VE Study Report

I-25 Operational Improvements Colorado Springs, CO

Subject: I-25 Operational Improvements, Fillmore to Garden of the Gods
Colorado Springs, CO
VE Study Report

Perform the Joint Replacement on the GOG Bridge Over a Weekend – Baseline

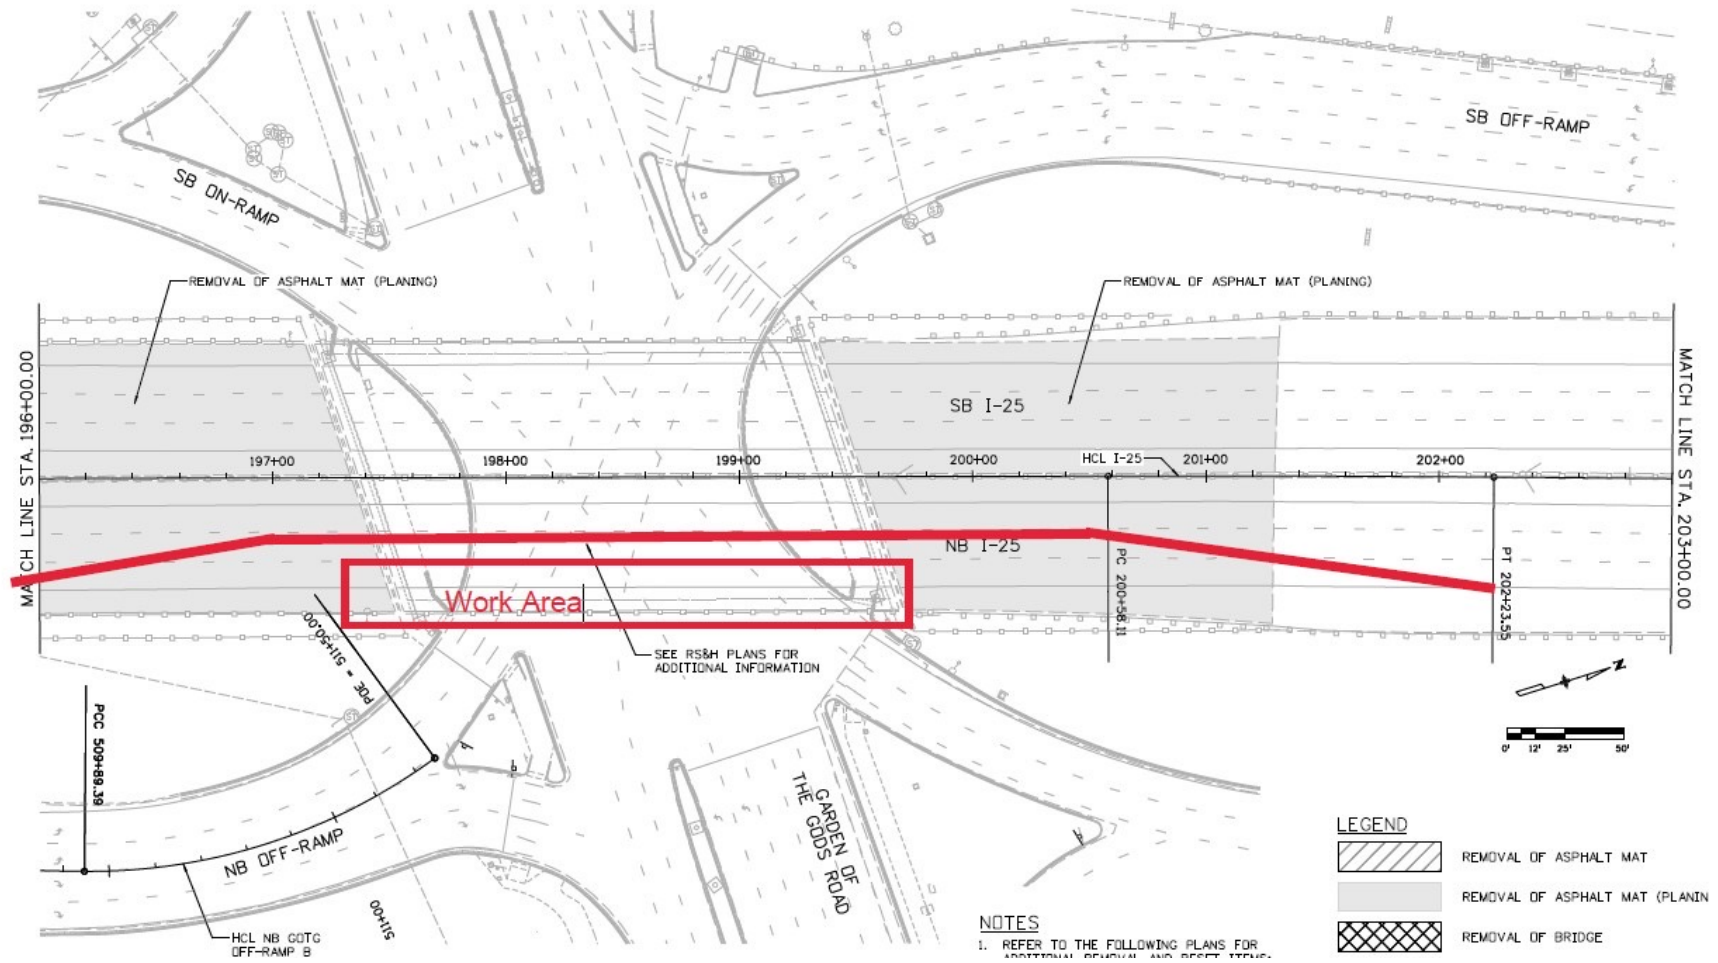
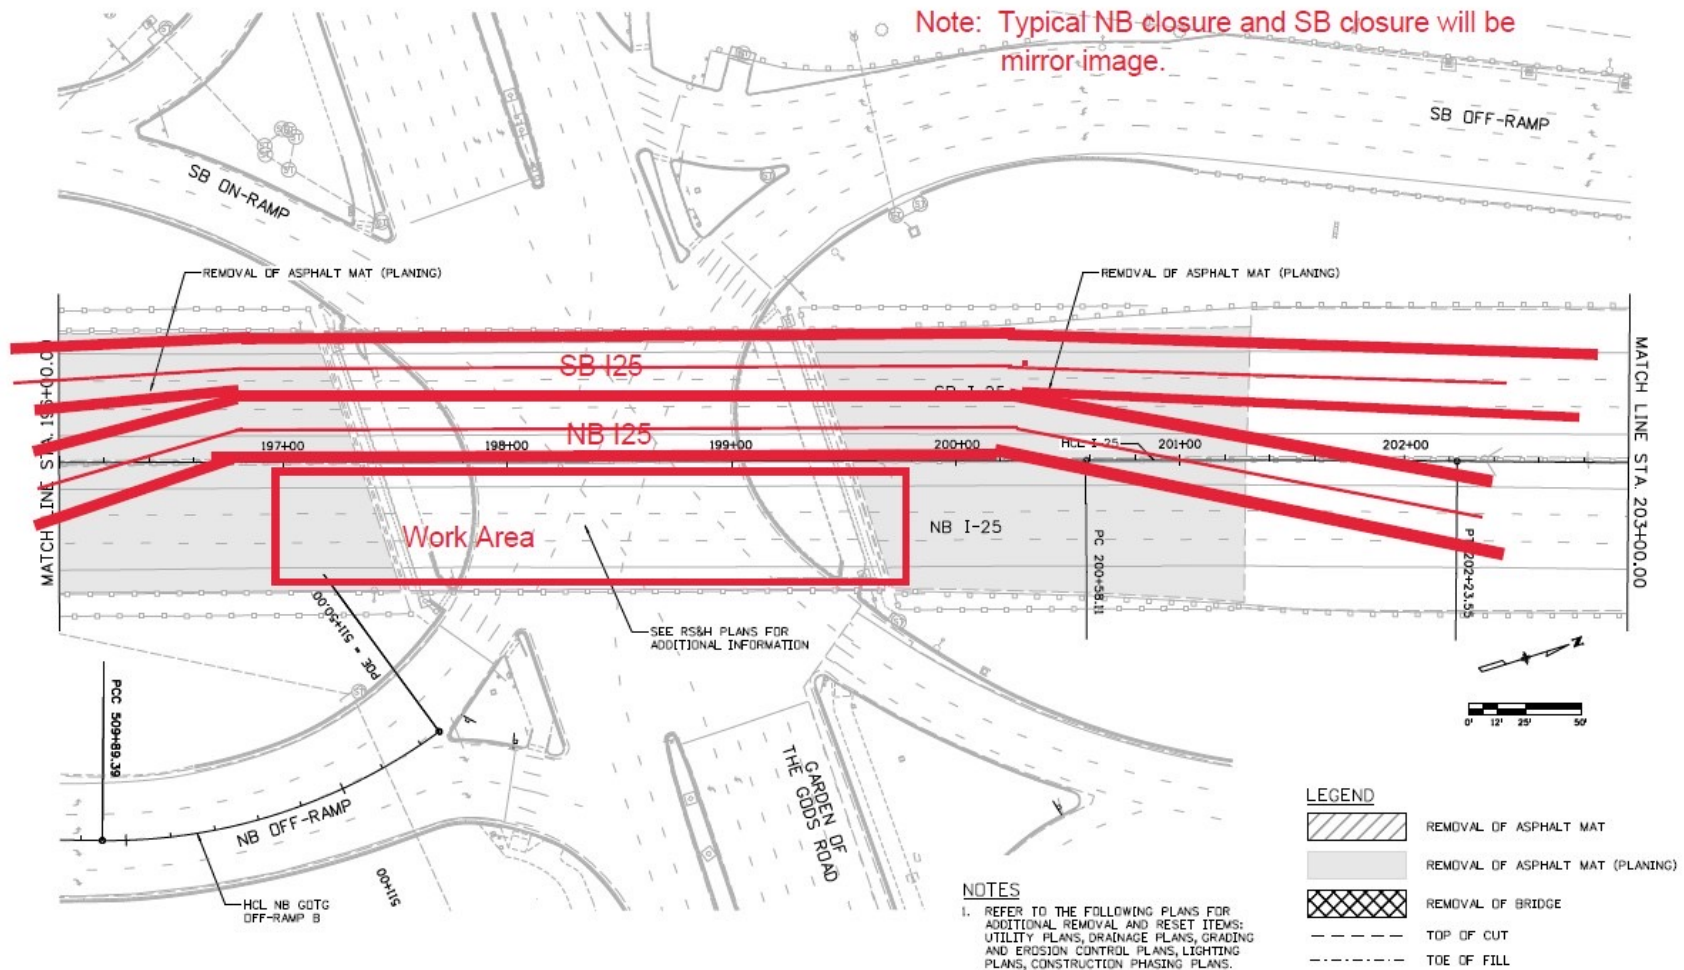
Perform removal and replacement of bridge expansion joint for both NB and SB GOG Bridge over a weekend.

Close NB Fillmore On-Ramp Intermittently – Potential Benefits

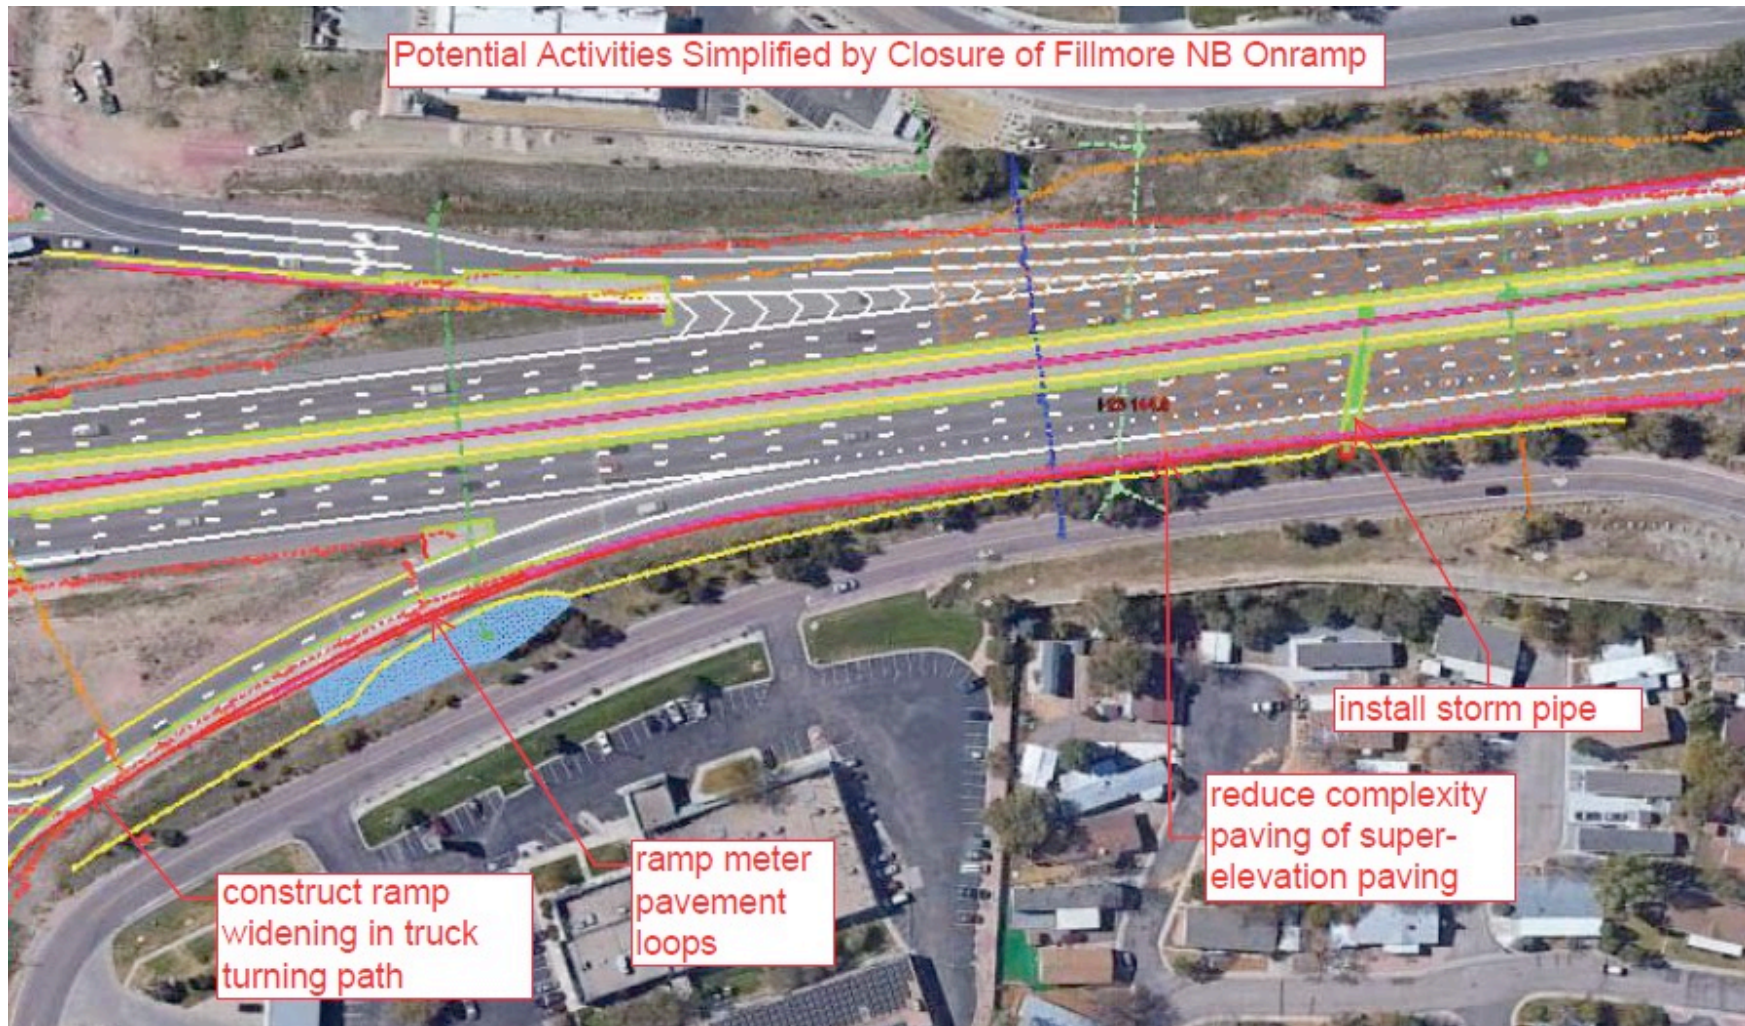
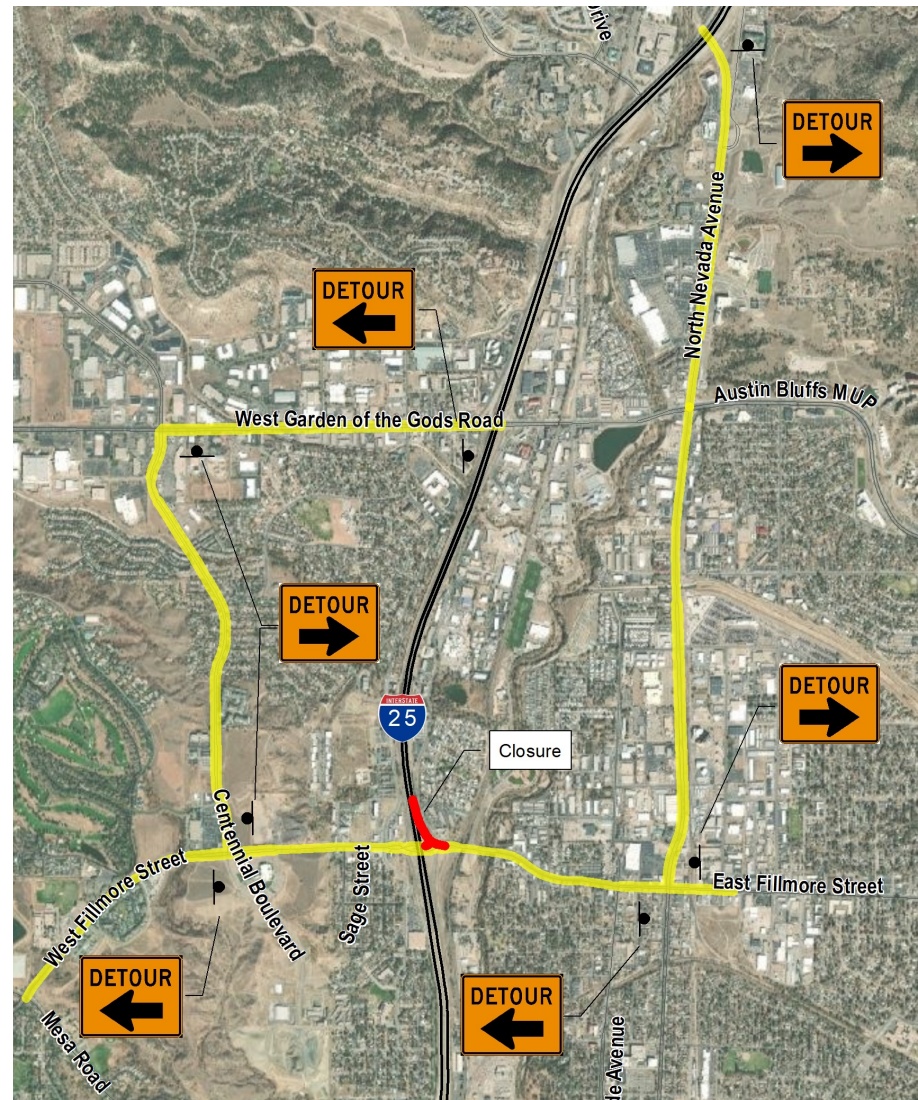
Close the Northbound (NB) Fillmore On-Ramp Temporarily During Construction
